SECY-96-057

FOR: The Commissioners
FROM: James M. Taylor
Executive Director for Operations
SUBJECT: RELOCATION OF EMERGENCY OPERATIONS FACILITY FOR SUSQUEHANNA
STEAM ELECTRIC STATION

SUSQUEHANNA STEAM ELECTRIC STATION
PROPOSED REVISION TO THE EMERGENCY
PLAN: MOVING THE EOF TO THE NORTHEAST
DIVISION HEADQUARTERS
PLA-4298 FILE R41-2

Attachment 1

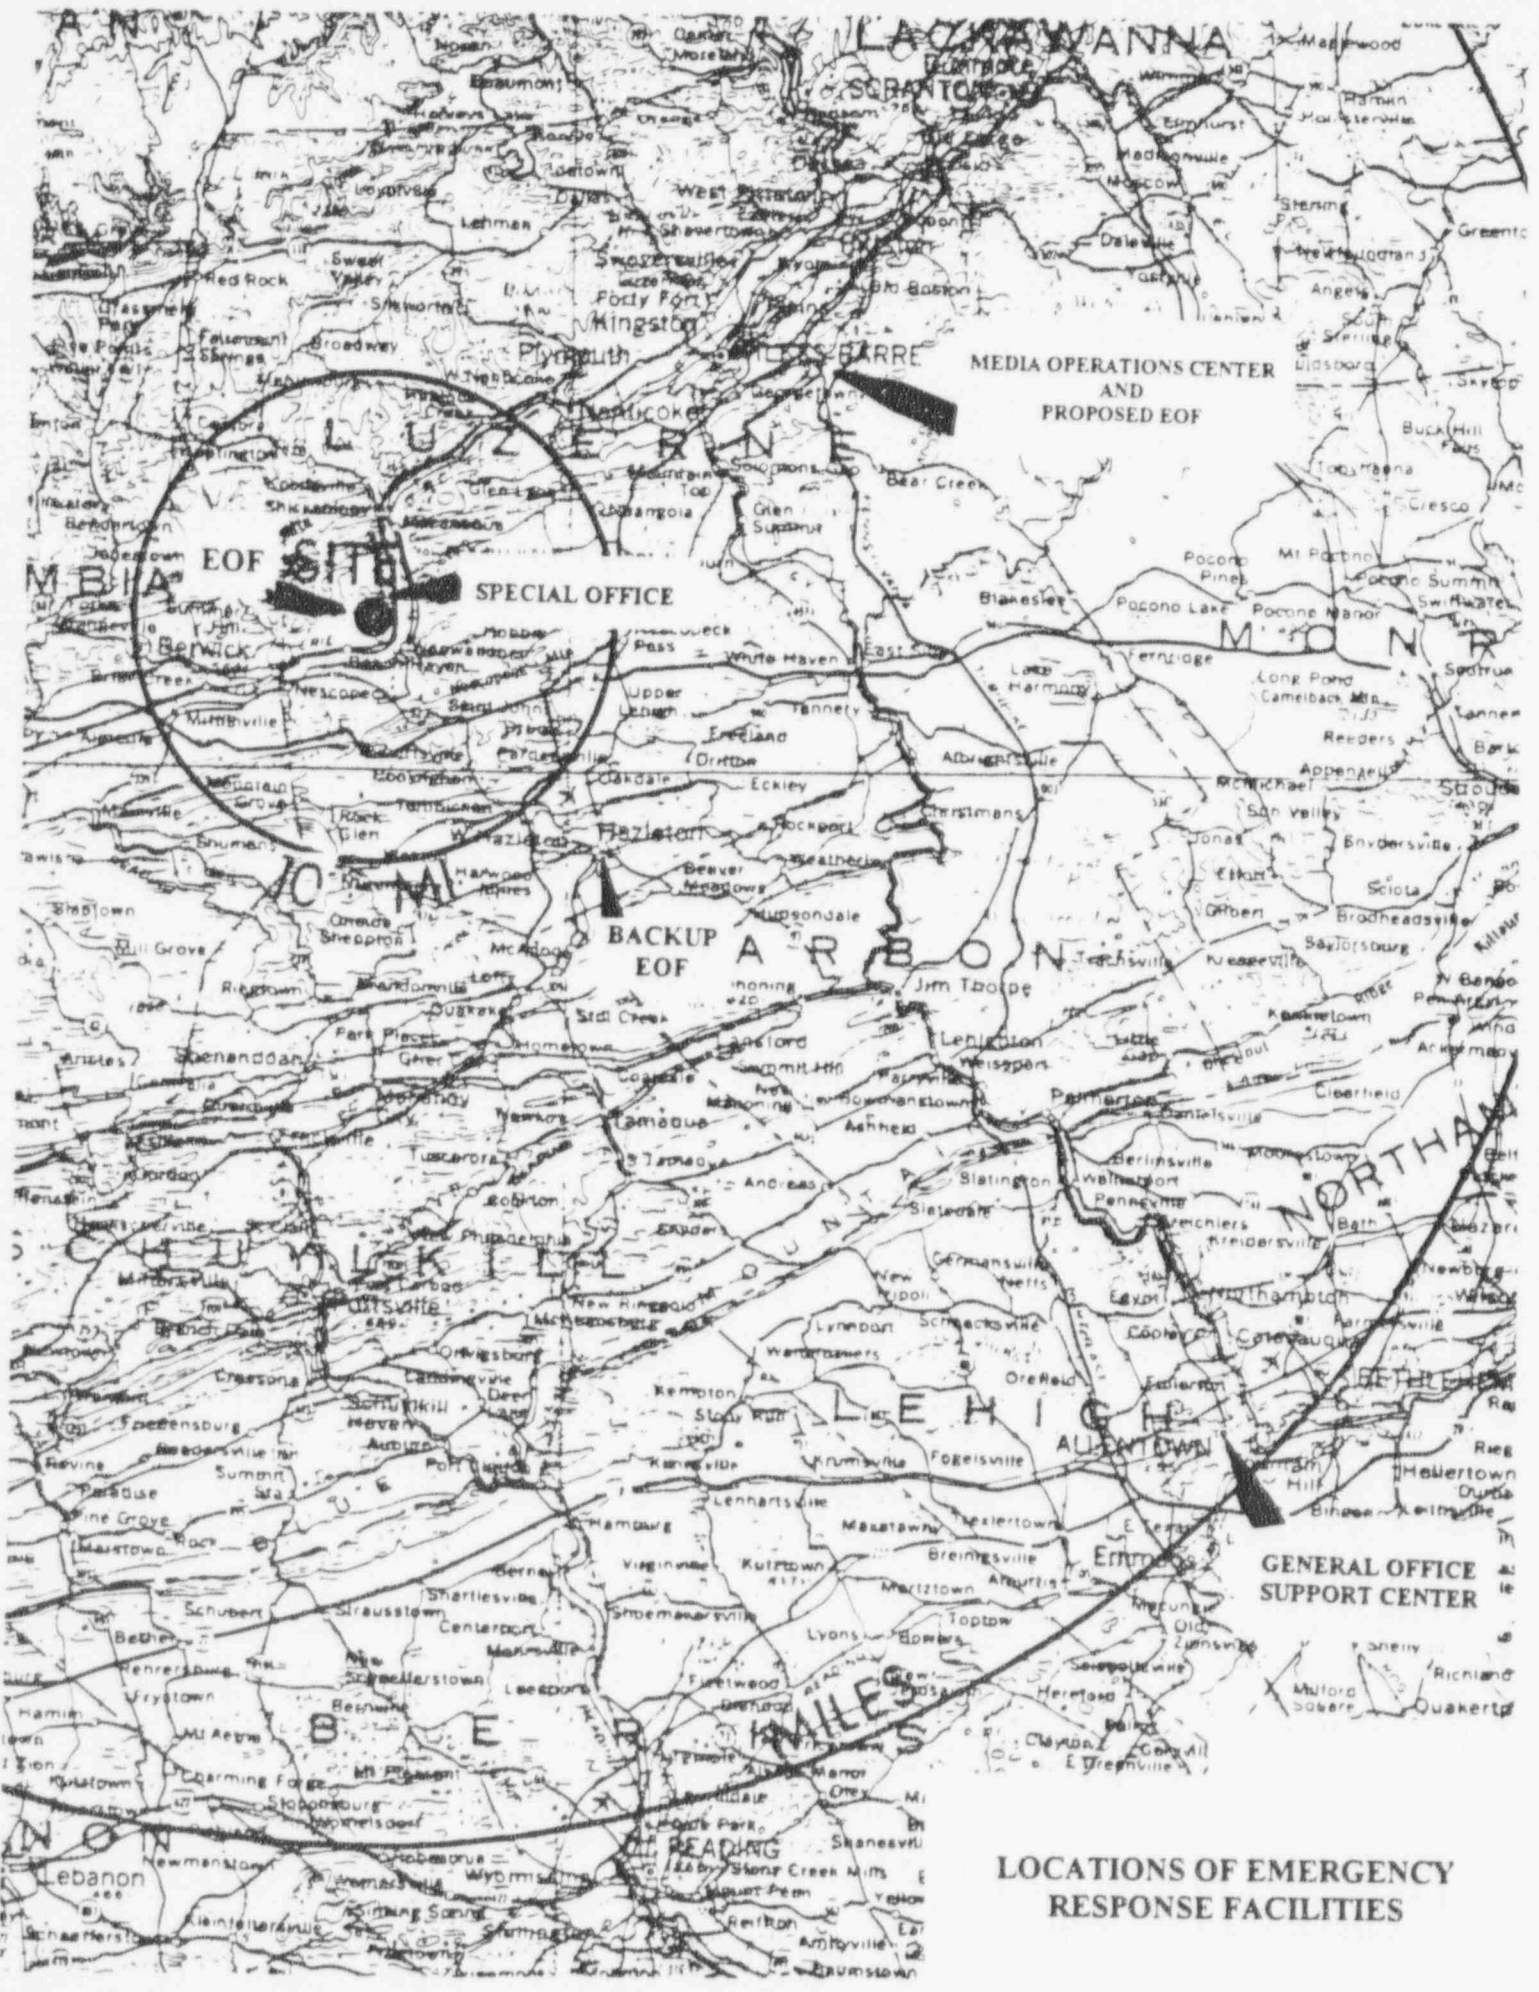
Attachment 1 shows the relative locations of our existing and proposed emergency response facilities.

FIGURE 6.2a

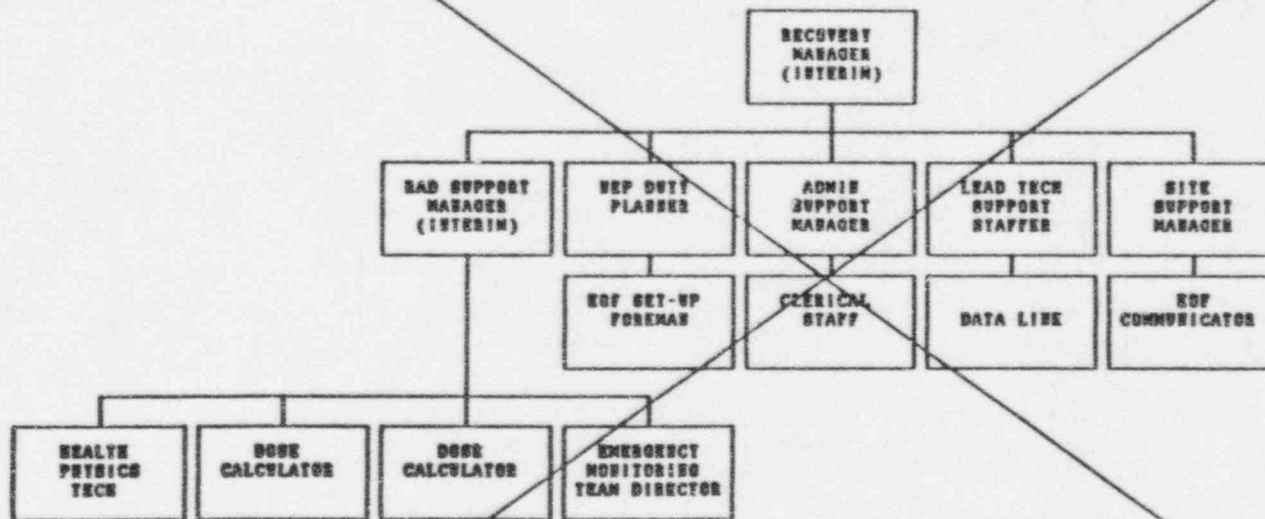
Phase III - Activation of Off-site NERO - (Reference Figures 6.2, ~~6.2a~~, 6.4, ~~6.4a~~ and Table 6.2). This organization staffs the Emergency Operations Facility, ~~General Office Engineering Support Center~~, and Media Operations ~~Facility~~ to provide in-depth technical and off-site radiologica' assessment.

FIGURE 6.2

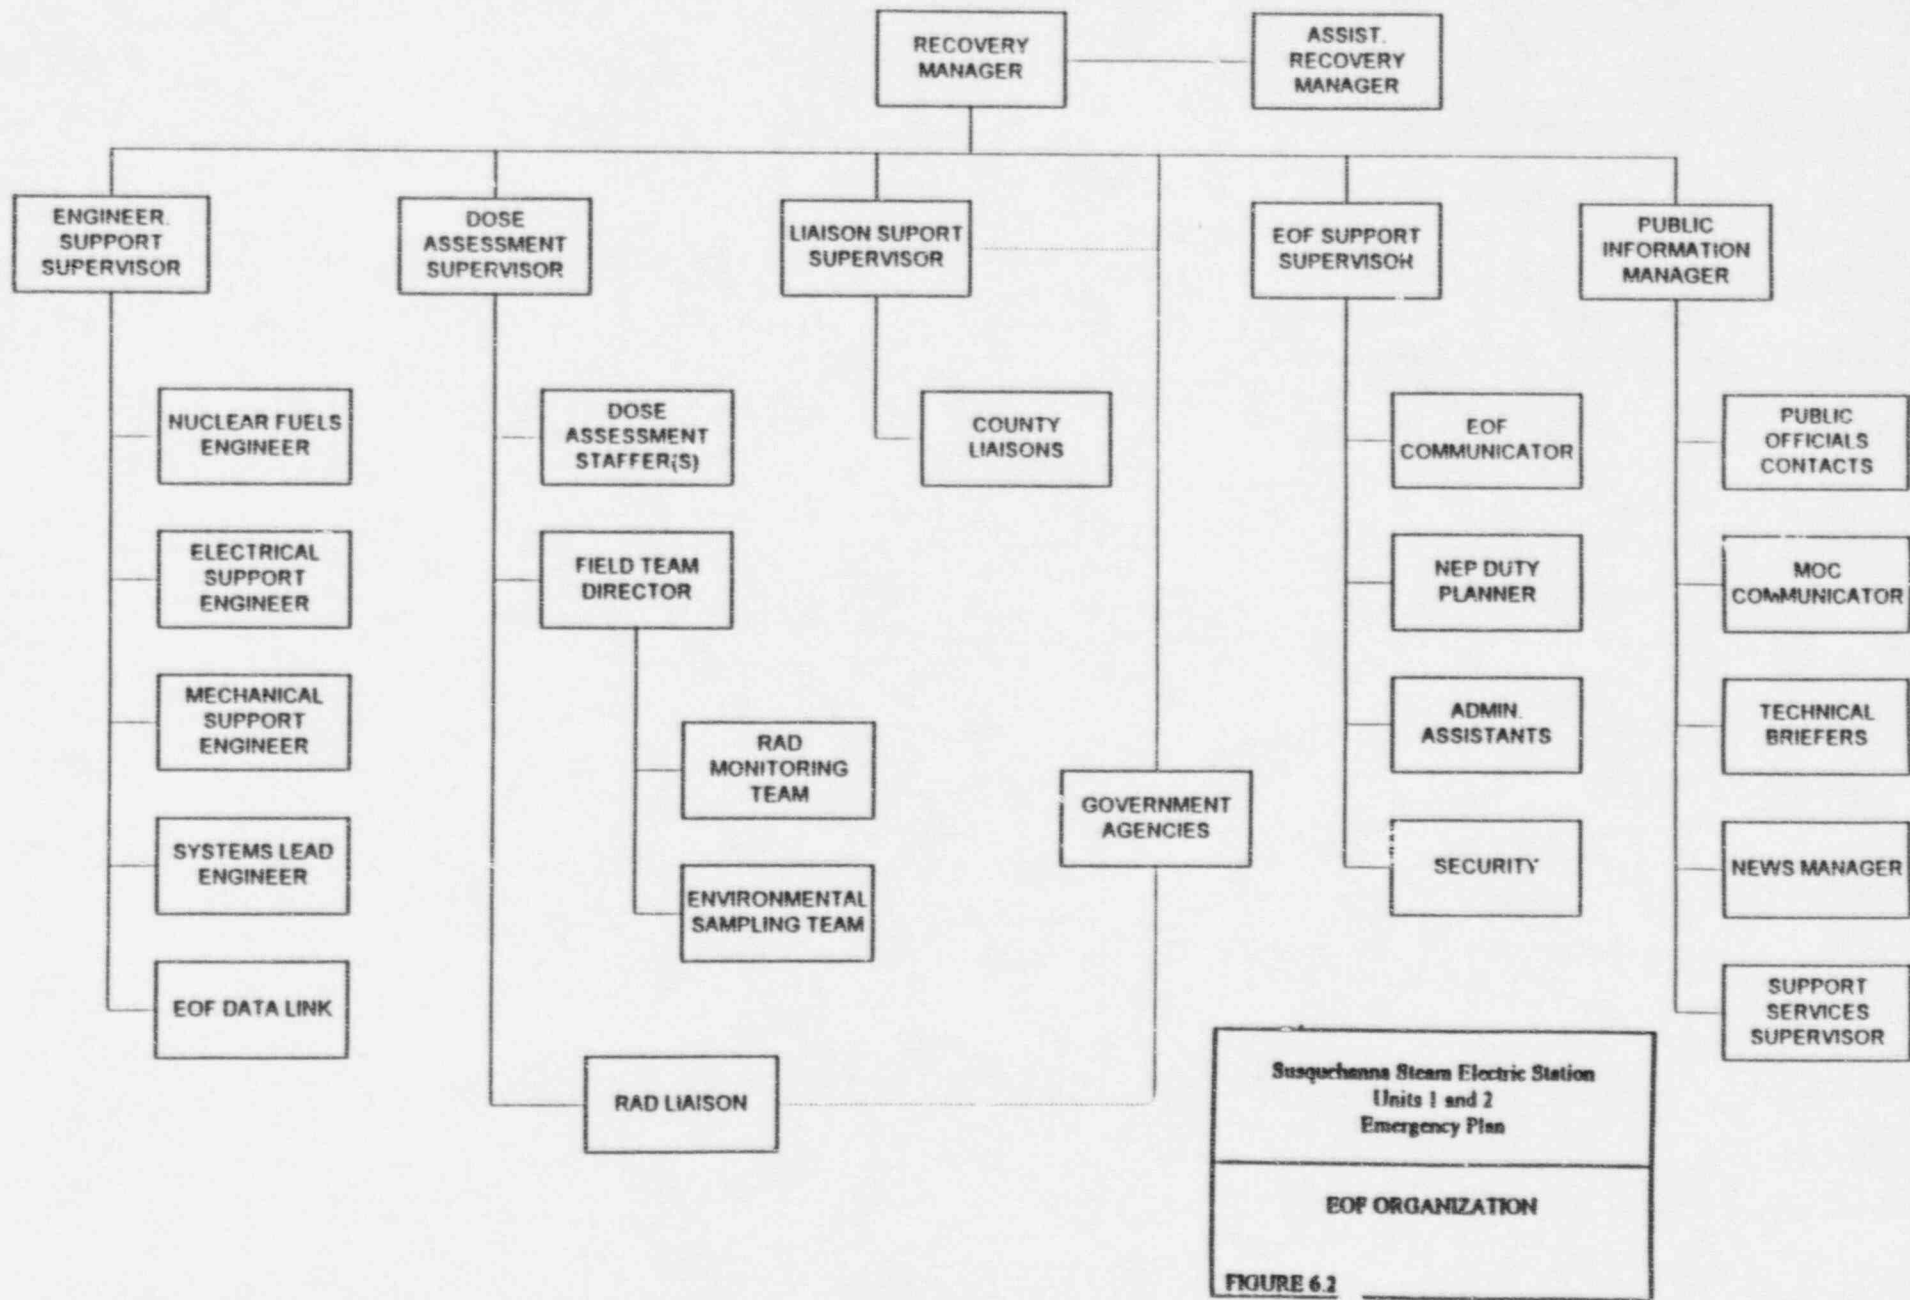
The EOF staff has been reorganized to strengthen its response capability. The positions directly reporting to the Recovery Manager have been realigned thus allowing him to manage the emergency more efficiently. Those positions directly reporting to the Recovery Manager are:

GENERAL OFFICE ENGINEERING SUPPORT FUNCTION

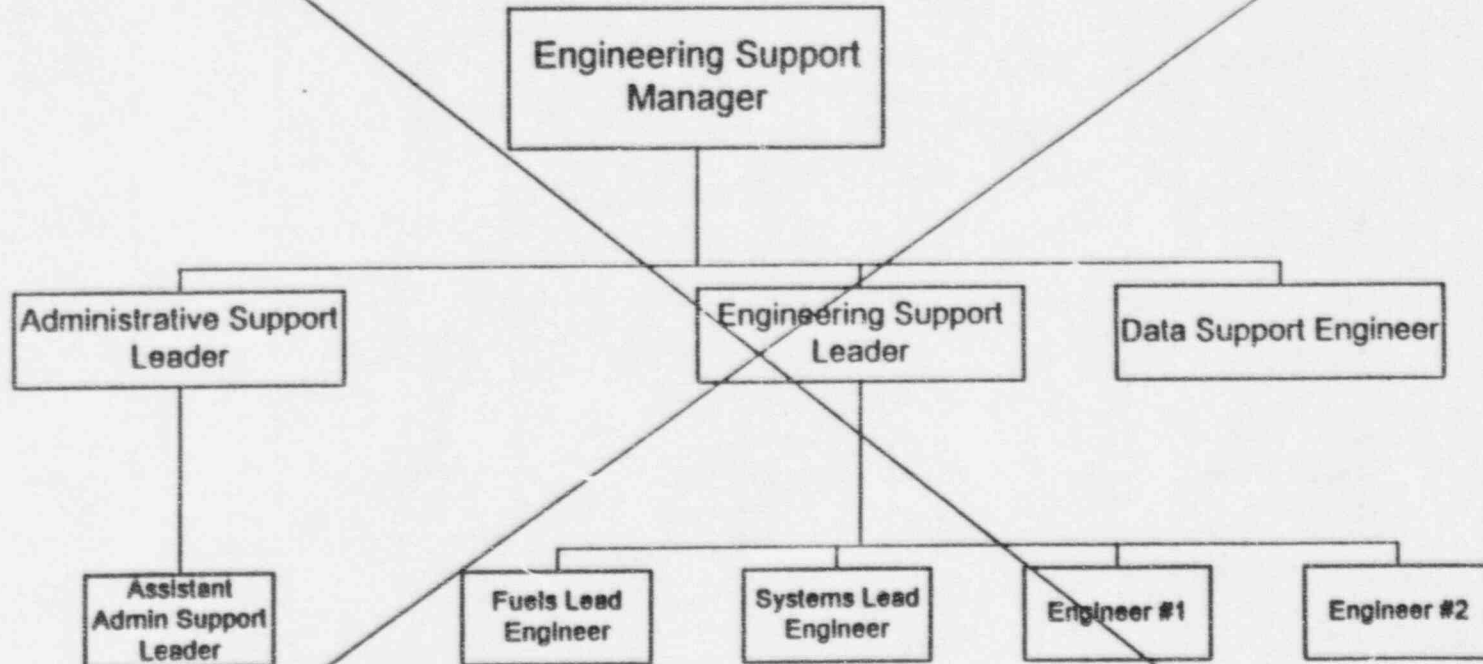
The General Office Engineering Support Center facility is no longer needed since additional engineering support has been added to the EOF staff. The engineering leads at the EOF can call in additional engineering staff as needed to respond to the emergency. The General Office Support Center has been eliminated from the Emergency Plan.

SUSQUEHANNA STEAM ELECTRIC STATION
 UNITS 1 AND 2
 EMERGENCY PLAN
 MAP OF SUSQUEHANNA SES
 EMERGENCY FACILITIES
 FIGURE 8.1

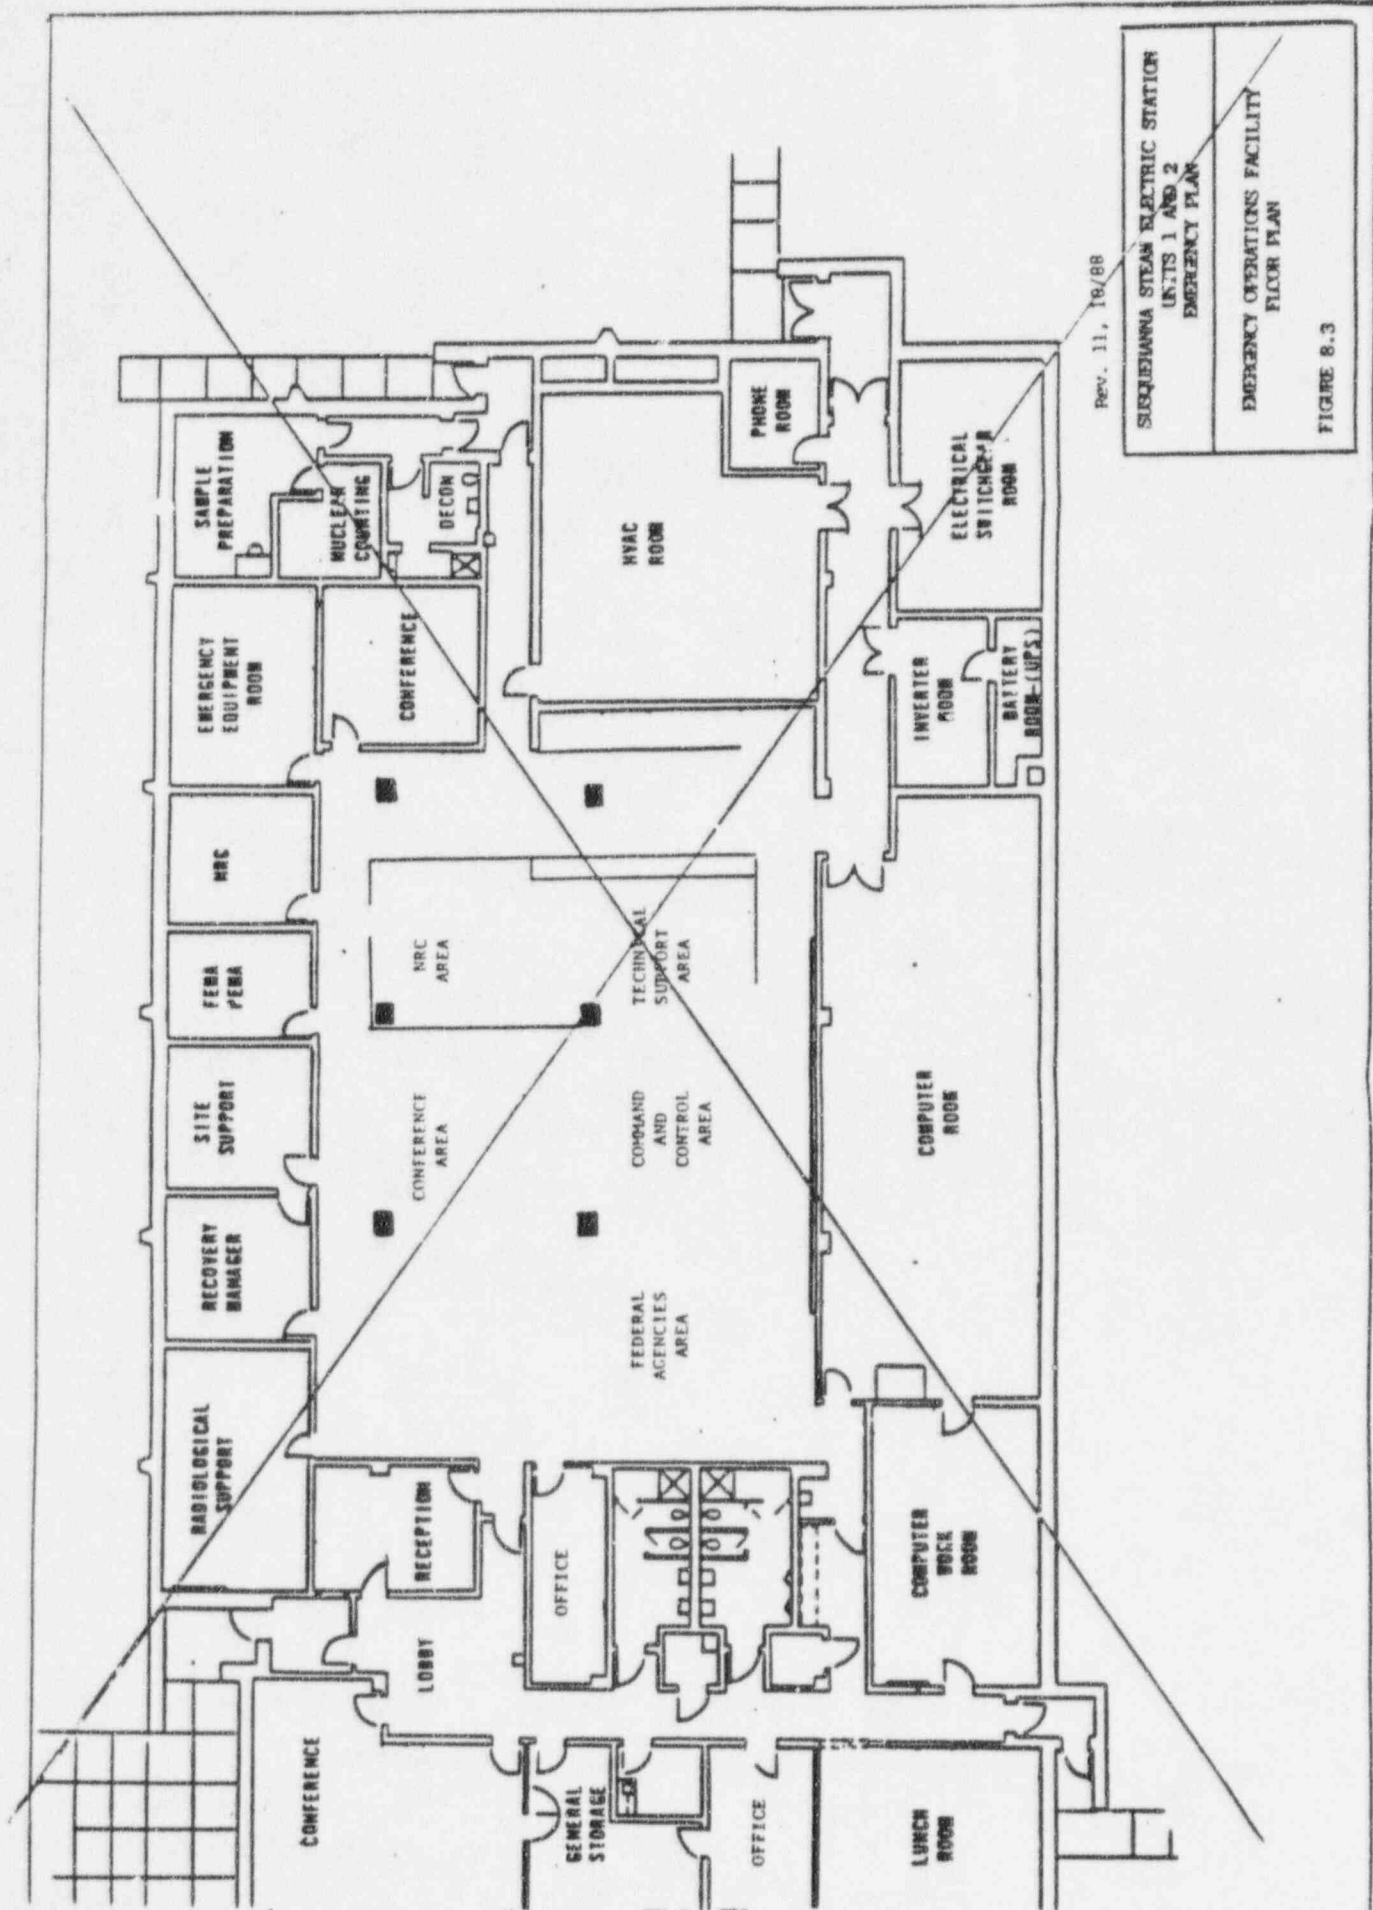
~~The site location of the EOF is in North Central Pennsylvania in Luzerne County approximately 5 1/4 miles north of the Borough of Berwick in Salem Township, approximately 2,500 feet southwest of the control structure (Reference Figure 8.1). The site fronts on County Road T-438. Direct access to the site is maintained over a 12' wide stoned roadway from Rt. T-438 to the 500kV Switchyard.~~
